UNITED STATES
NUCLEAR REGULATORY COMMISSION
REGION II
101 MARIETTA STREET, N.W.
ATLANTA, GEORGIA 30323

Report Nos.: 50-369/87-46 and 50-370/87-46

Facility Name: McGuire 1 and 2

Inspection Conducted: November 7, 1987 - January 13, 1988

COMPONENT COOLING HX TEST RESULTS

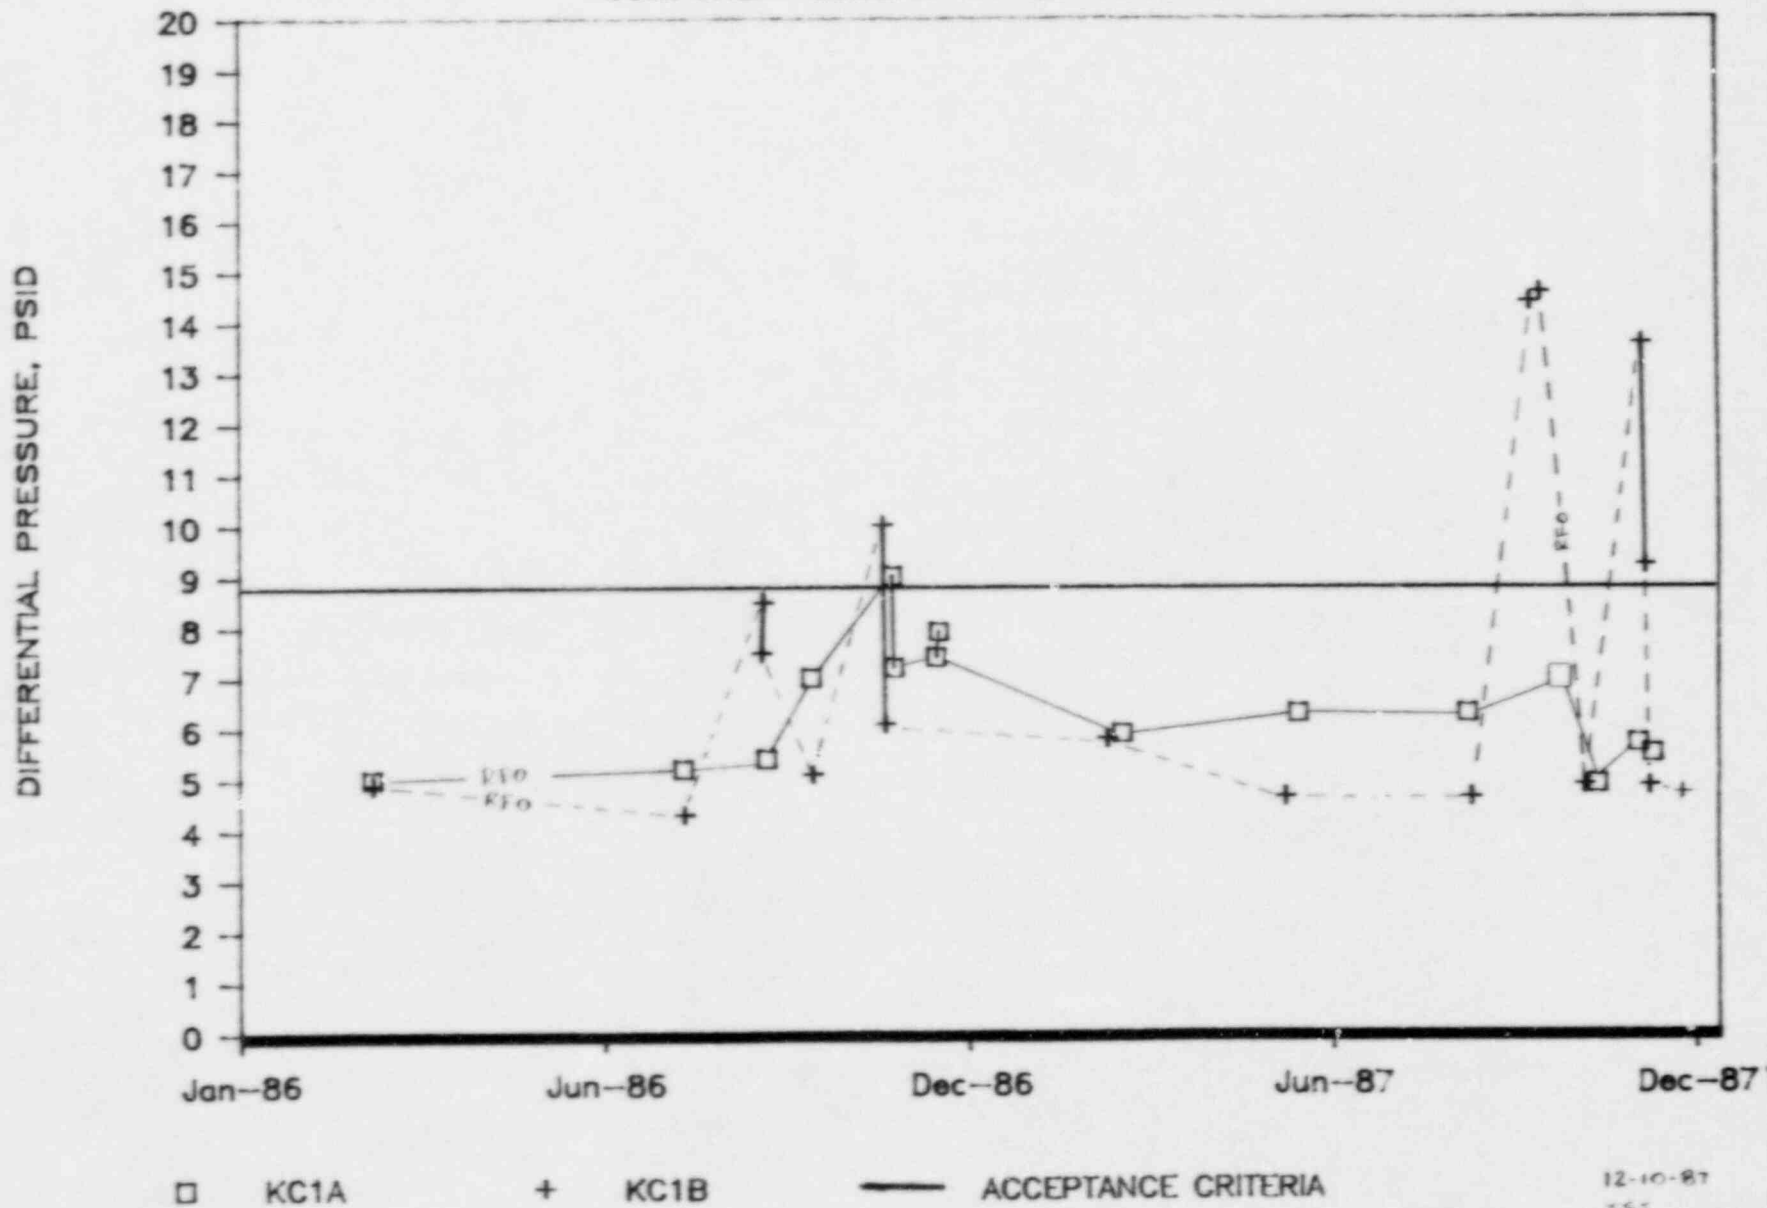
- a. The test program, established to demonstrate that the KC system will perform satisfactorily in service, was inadequate in that five of the six tests performed between the dates of September 4 and October 9, 1987 failed. The test program, by design, was established to maintain system operability. The repeated test failures of the KC heat exchangers is, sufficient to question program adequacy.

COMPONENT COOLING HX TEST RESULTS

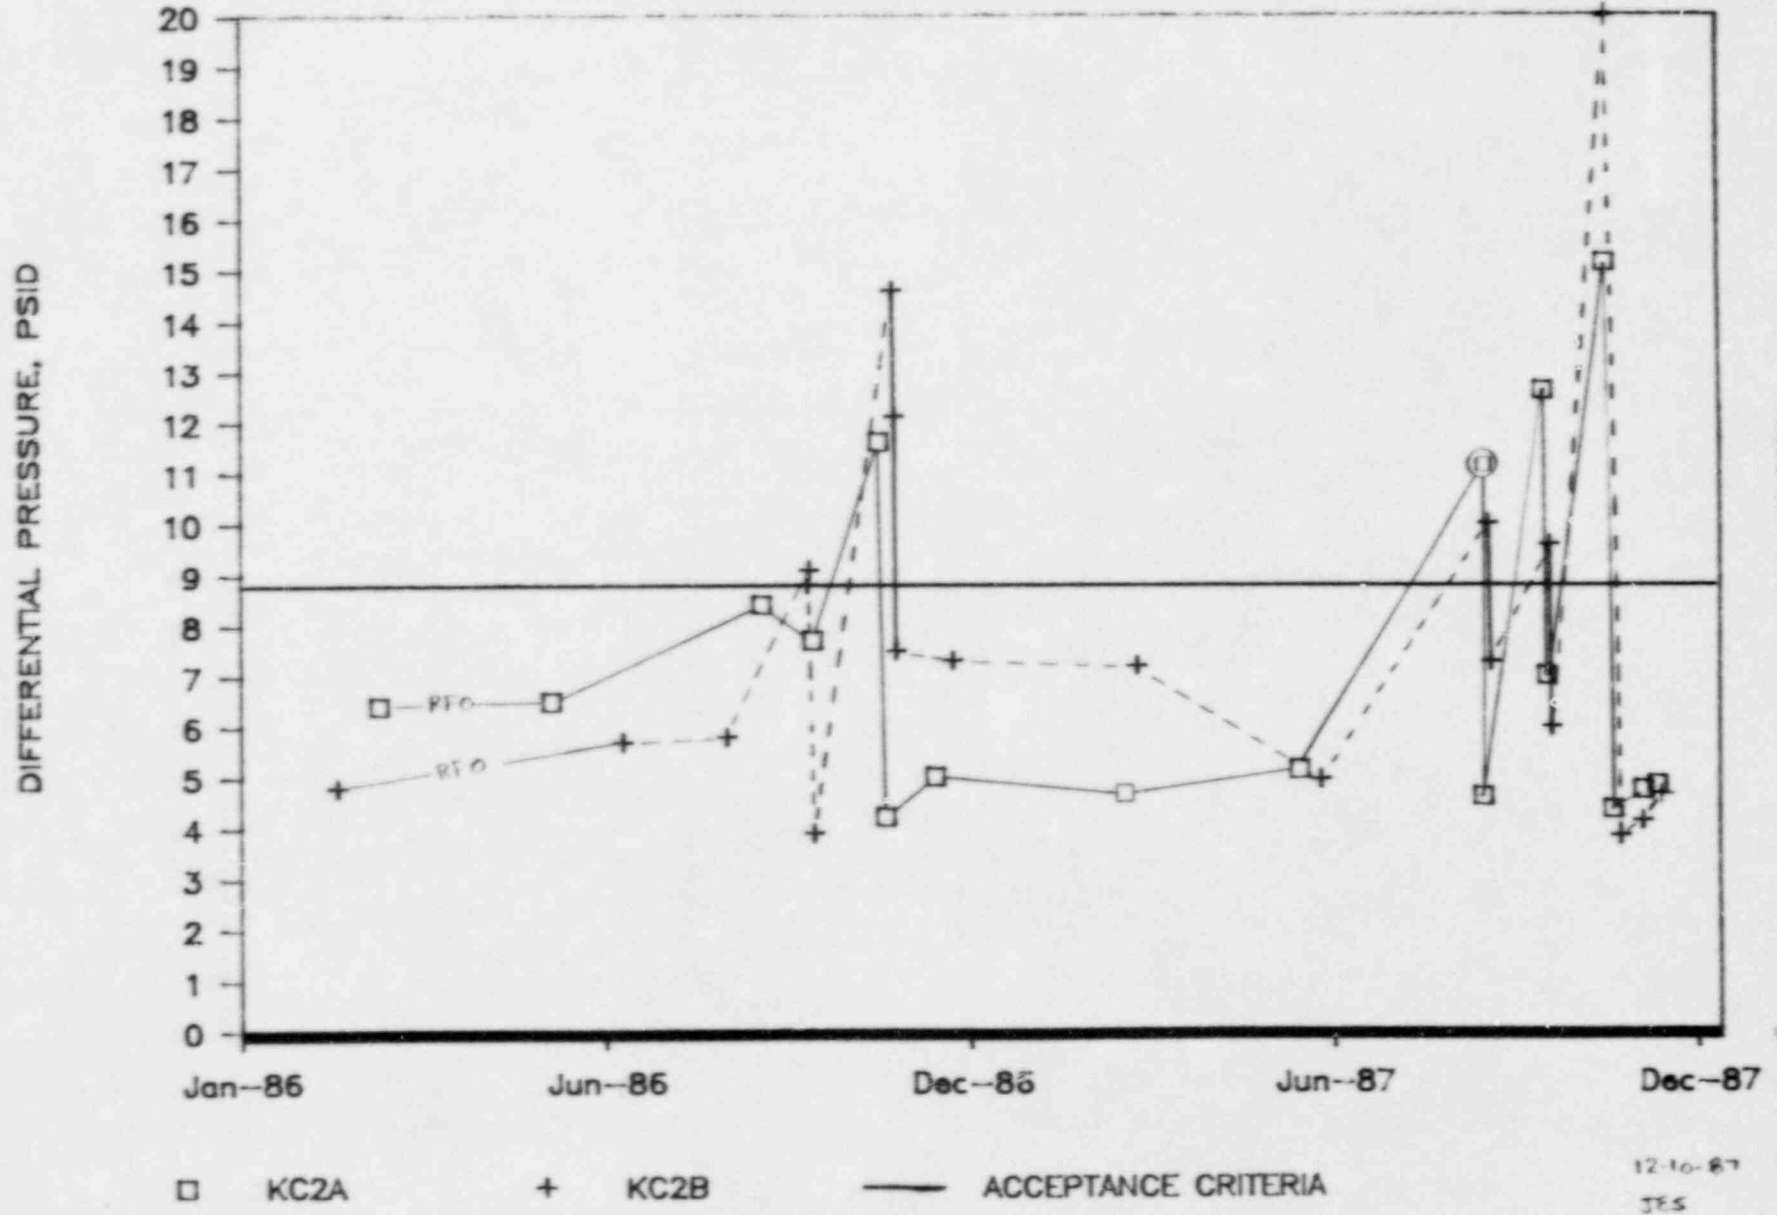
As illustrated on page 2 of Attachment 1, a plot of the McGuire Unit 2 KC heat exchanger test data for 1986 and 1987, there was at least one occurrence in the fall of 1986 and two in the fall of 1987 prior to the November 7 event, during which both trains of KC appear to have been inoperable simultaneously. Furthermore, if the Unit 1 KC heat exchanger test results are included in the analysis, there were five failures out of the six tests performed between September 4 and October 9, 1987.

Of concern is an apparent pattern of inoperability of these heat exchangers, and the restart of the unit on November 7, with what appears to be adequate information available prior to the unit restart forecasting the heat exchangers' degradation. This pattern is graphically depicted on Attachment 1.

- b. Test data indicates that both Unit 2 KC heat exchangers were inoperable simultaneously; once during the Fall of 1986 and a number of times during the Fall of 1987, when the unit was operating in modes requiring both trains to be operable.

Subsequent licensee analysis revealed however that based on a model assuming uniform depositing of silt on the HX tubes, the limiting DP for design basis heat transfer is 16.0 psid. Assuming that type of debris geometry, only one KC HX (2B) was actually inoperable during the Fall of 1987. The licensee's safety analysis is entailed in LER 370/87-22.
